Re: Final Responses to NRC Comments Dated April 13, 1981 - Sand Rock Mill Project - NRC Docket No. 40-8743

Additional Data for Comment No. 20

SAND ROCK MILL PROJECT
NRC DOCKET NO. 40-8743
JUNE, 1981

CONOCO INC. MINERALS DEPARTMENT 555 Seventeenth St. Denver, CO 80202		
SAND ROCK MILL PROJECT CAMPBELL COUNTY, WYOMING		
EVAPORATION POND AREA CLAY MINERALS SAMPLE SITES		
Date: 5/21/81	Drawn By: M.D.	Figure 1

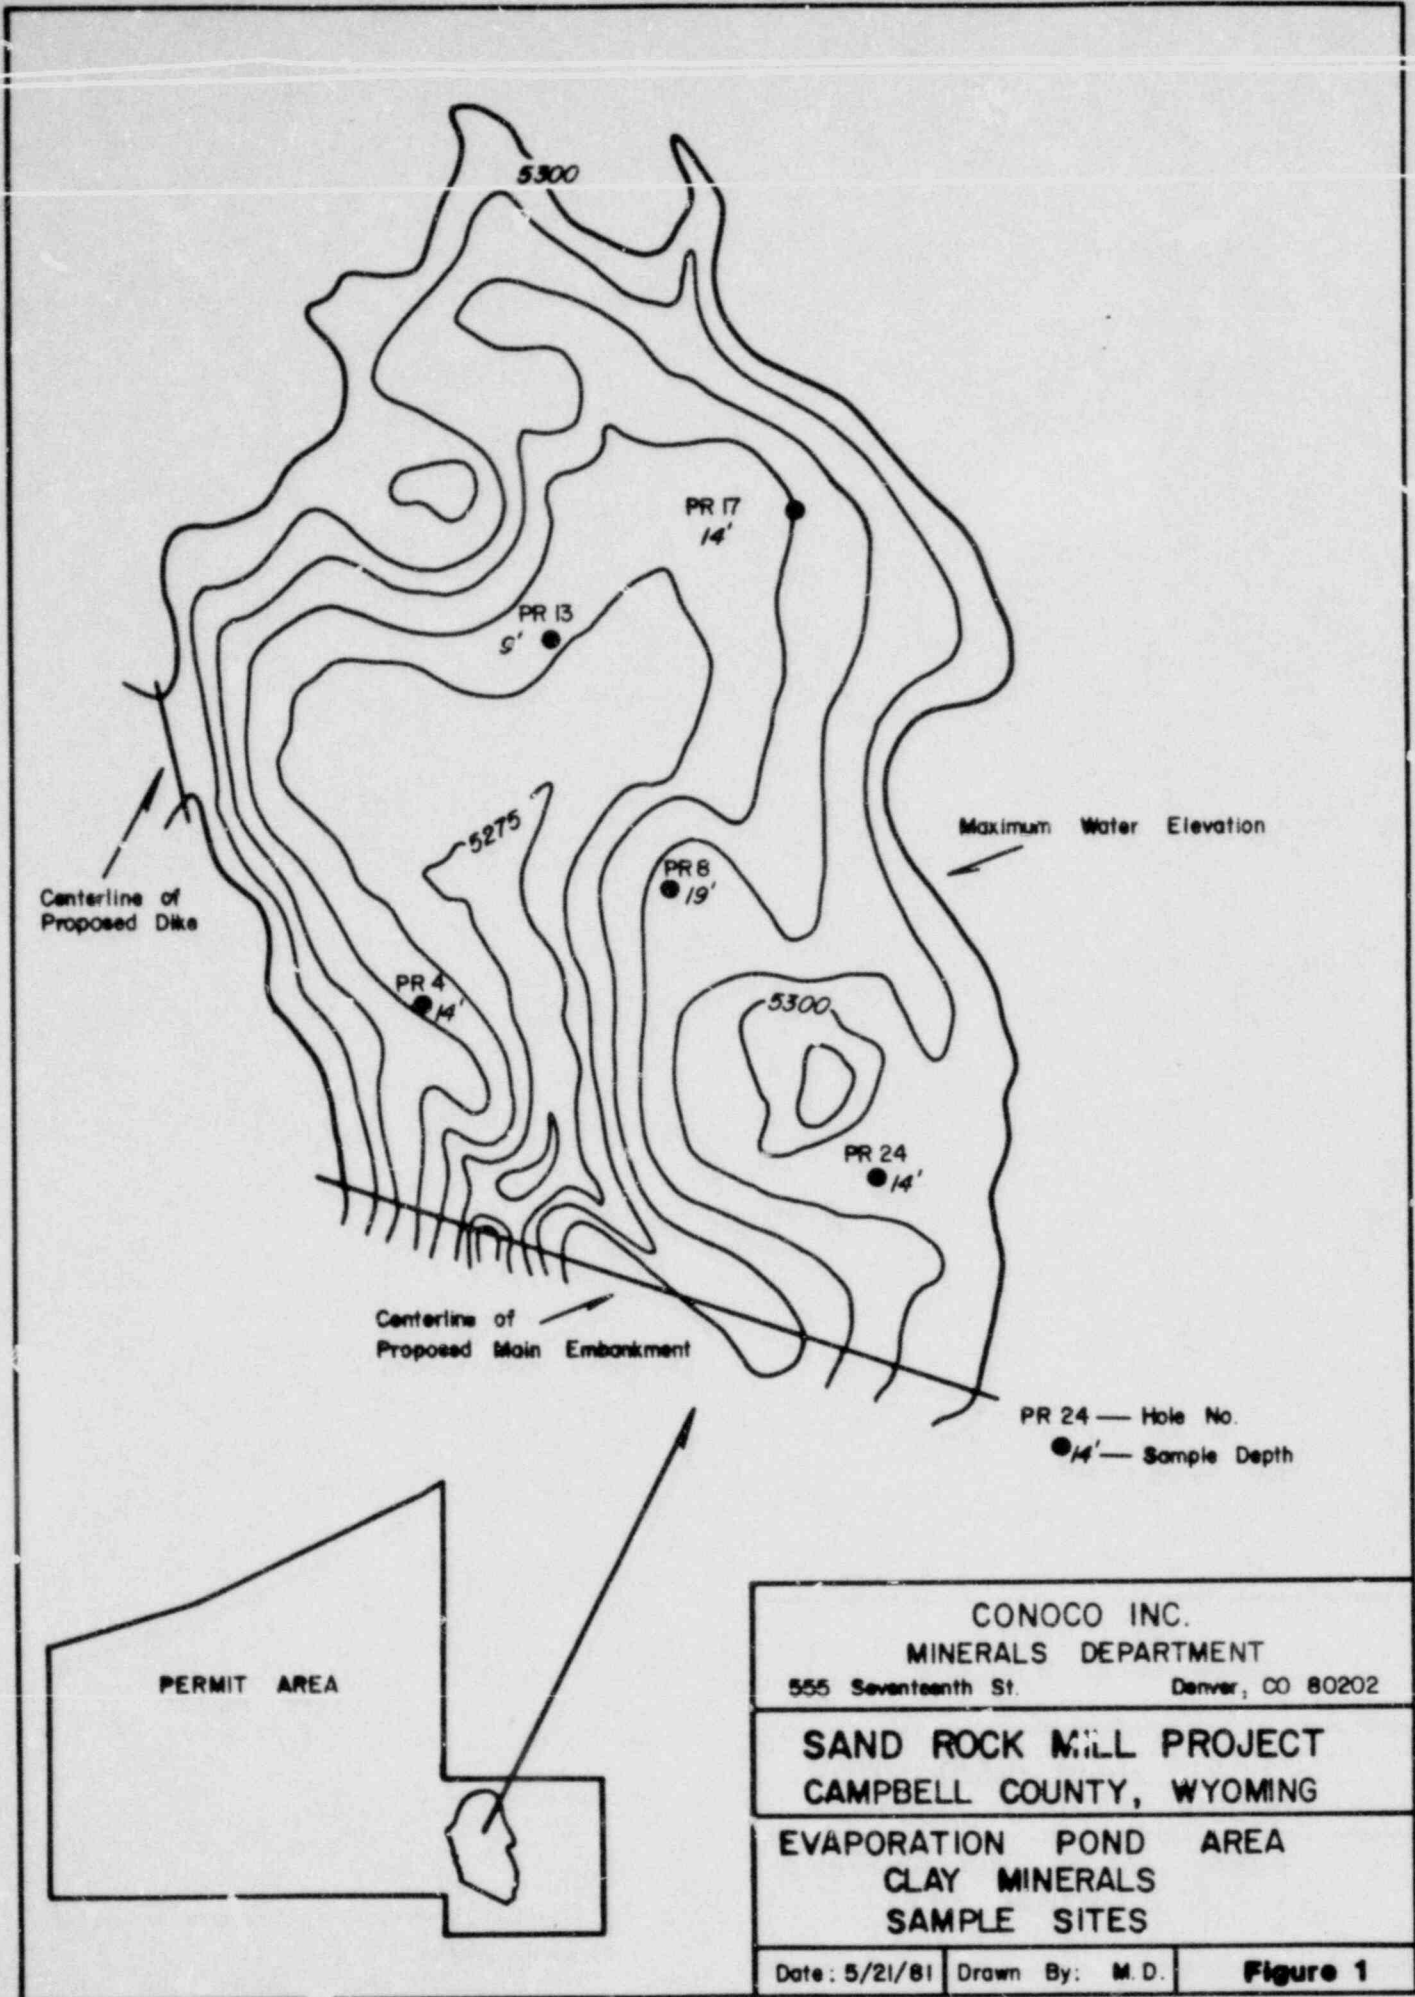
In the pit and evaporation pond, natural clay materials will be relied upon to minimize seepage either in their existing state or as compacted clay liners. Furthermore, tailings solutions will be in direct contact with the evaporation pond embankment. Provide test data to indicate the long-term stability and non-dispersivity of the site-specific clay materials in contact with low pH tailings solution. The data presented for pin hole tests in Appendix C of Chen and Associates' report 6210B-W, July 25, 1980, does not indicate the nature of the water that was used in those tests.

Five samples were taken from the claystone bedrock that underlies the Sand Rock evaporation pond site (Figure 1). Core descriptions of these five sample drill holes can be found in the Sand Rock ER Reference Document Chen (1980).

This claystone bedrock will form the pond bottom once the surface alluvium and the sandstone strata above the claystone has been stripped away and stockpiled.

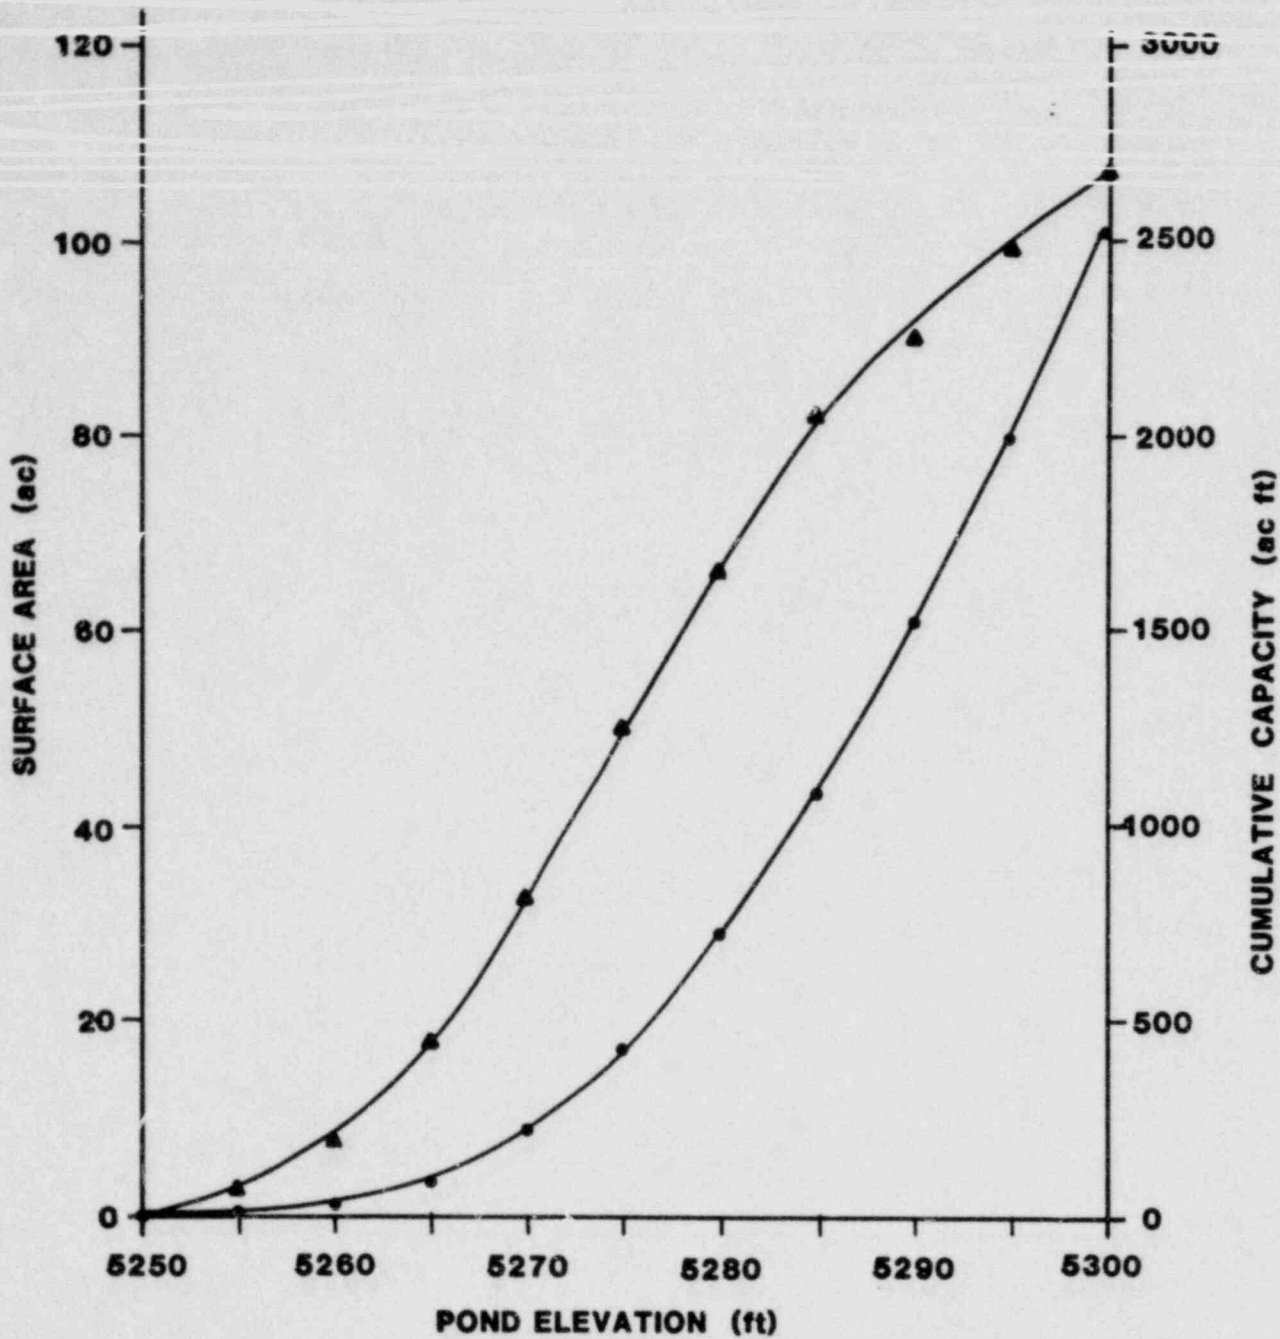
Provide stage-volume-area curves for the evaporation pond and the tailings pit. These curves should be integrated with the five-phase deposition plan and should consider both tailings and water volume.

The requested information is attached.
